Subject: ADDENDUM NO. 3

Project: A NEW SECURITY & SERVICES TRAINING FACILITY

Job #: ANG# BRKR009063 / SSL# 12072

ELECTRICAL DEMOLITION SITE PLAN

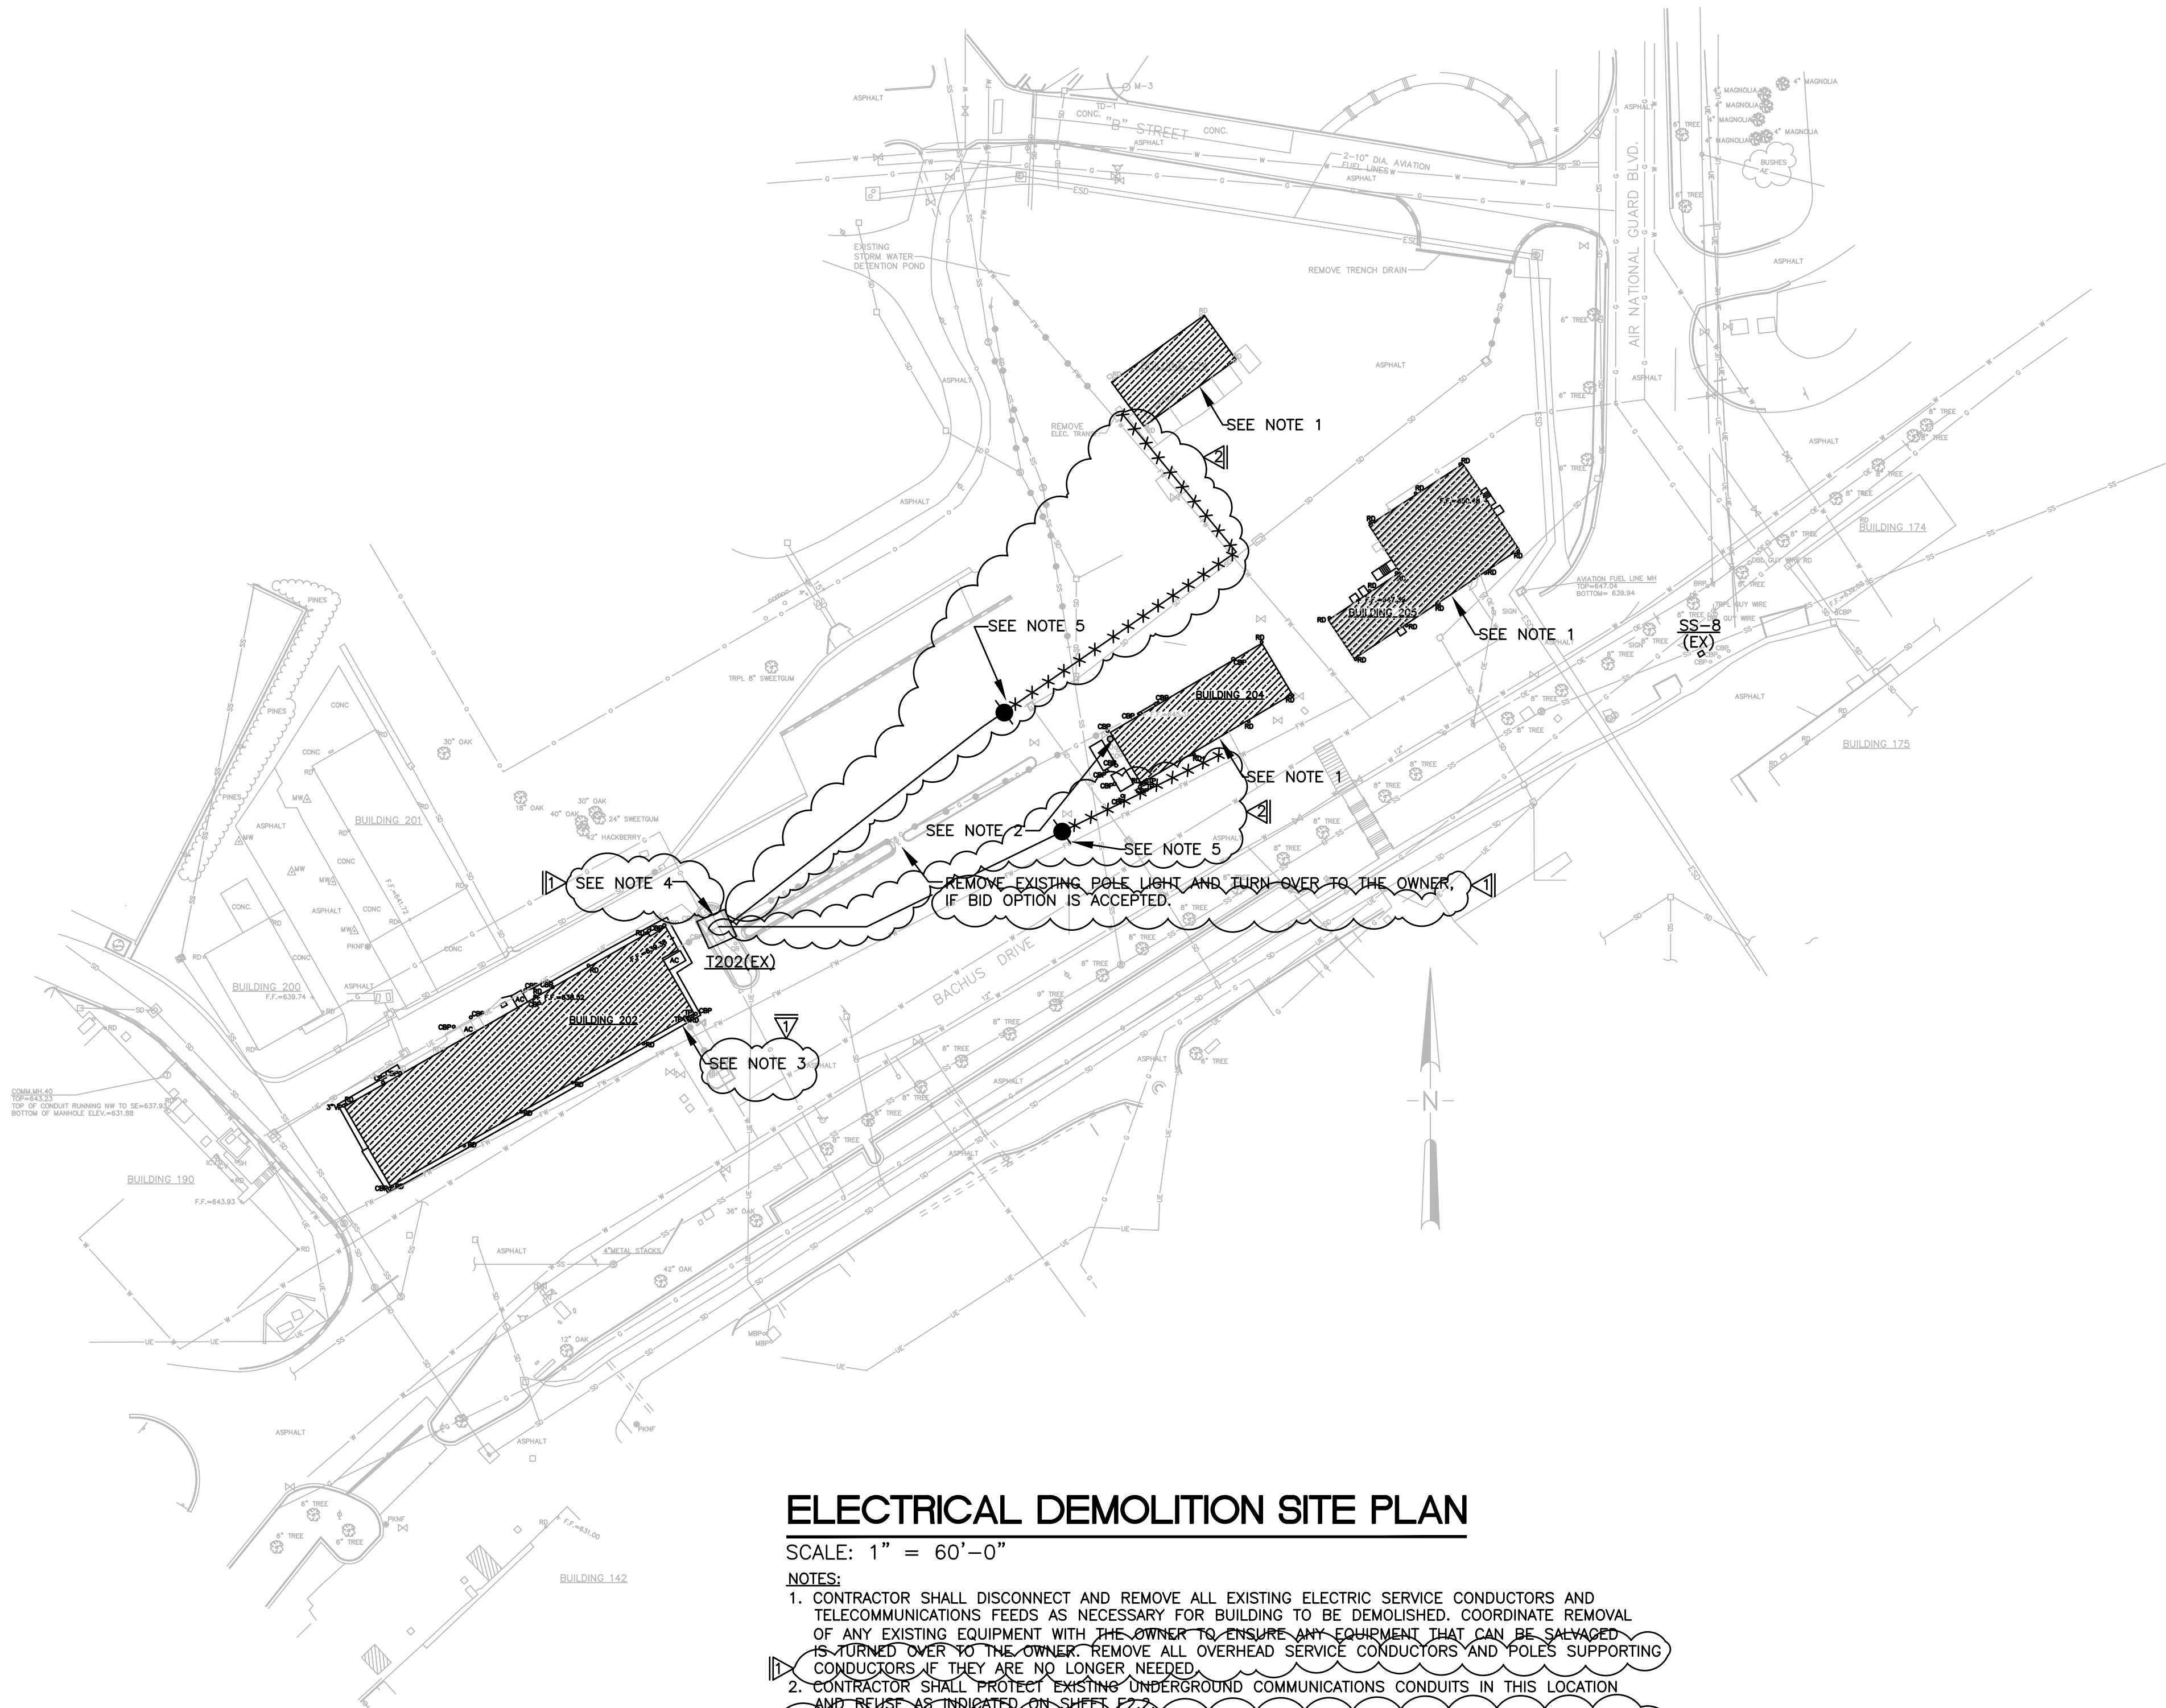
1. C2.1 Site Demolition Plan (Base Bid)
- Item No. 3:** Refer to electrical drawings. Delete the following drawing sheets and replace them with the attached drawing sheets with a revised date of 23 January 2023. Revisions are noted with revision cloud.

- NOTES:
1. CONTRACTOR SHALL DISCONNECT AND REMOVE ALL EXISTING ELECTRIC SERVICE CONDUCTORS AND TELECOMMUNICATIONS FEEDS AS NECESSARY FOR BUILDING TO BE DEMOLISHED. COORDINATE REMOVAL OF ANY EXISTING EQUIPMENT WITH THE OWNER TO ENSURE ANY EQUIPMENT THAT CAN BE SALVAGED IS TURNED OVER TO THE OWNER. REMOVE ALL OVERHEAD SERVICE CONDUCTORS AND POLES SUPPORTING CONDUCTORS IF THEY ARE NO LONGER NEEDED.

2. CONTRACTOR SHALL PROTECT EXISTING UNDERGROUND COMMUNICATIONS CONDUITS IN THIS LOCATION AND REUSE AS INDICATED ON SHEET E2.2.
 3. IF BID OPTION IS AWARDED, CONTRACTOR SHALL DISCONNECT AND REMOVE ALL EXISTING ELECTRIC SERVICE CONDUCTORS AND TELECOMMUNICATIONS FEEDS AS NECESSARY FOR BUILDING TO BE DEMOLISHED. COORDINATE REMOVAL OF ANY EXISTING EQUIPMENT WITH THE OWNER TO ENSURE ANY EQUIPMENT THAT CAN BE SALVAGED IS TURNED OVER TO THE OWNER.

4. EXISTING TRANSFORMER T202 SHALL REMAIN IN PLACE EVEN IF THE BID OPTION TO DEMOLISH BUILDING 202 IS TAKEN. REMOVE ALL SECONDARY CONDUCTORS AS REQUIRED.

5. APPROXIMATE LINE OF DEMOLITION OF ASPHALT IN BASE BID - REFER TO CIVIL. REMOVE CONDUCTORS AND CONDUIT ON EAST/NORTH SIDES OF THIS POINT. ABANDON CONDUIT IN PLACE TO SOUTH/WEST OF THIS LINE. IF BID OPTION #3 IS AWARDED, REMOVE CONDUCTORS AND CONDUITS ALL THE WAY BACK TO POINT OF ORIGIN AT T202.
